Mueller Co.
GAS PRODUCTS DIVISION

Product Advisory

Valve Changer Tailpiece Kit

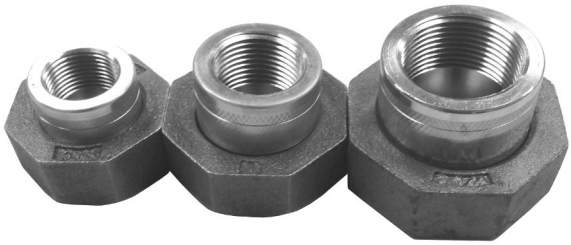
When using the NO BLO® Valve Changer with an insulated union tailpiece, the Plugging Unit passes through a restricted area of the union which might interfere with its operation. To avoid this situation, a special full bore ID tailpiece kit is available. Three sizes are included for use on ¾″, 1″ and 1¼″ insulated meter valves. The special tail piece is intended to be used temporarily in place of the regular insulated tailpiece, and used to attach the Valve Changer and Plugging Unit to the valve.

Using a tail piece from this kit will help to assure a smooth transition of the Plugging Unit's rubber plug as it is moved through the special tail piece and upstream of the valve body.

The kit is available as Part No. 682993. In addition, the kit has been added as a standard item included with H-17010 Valve Changer Plugging Units.
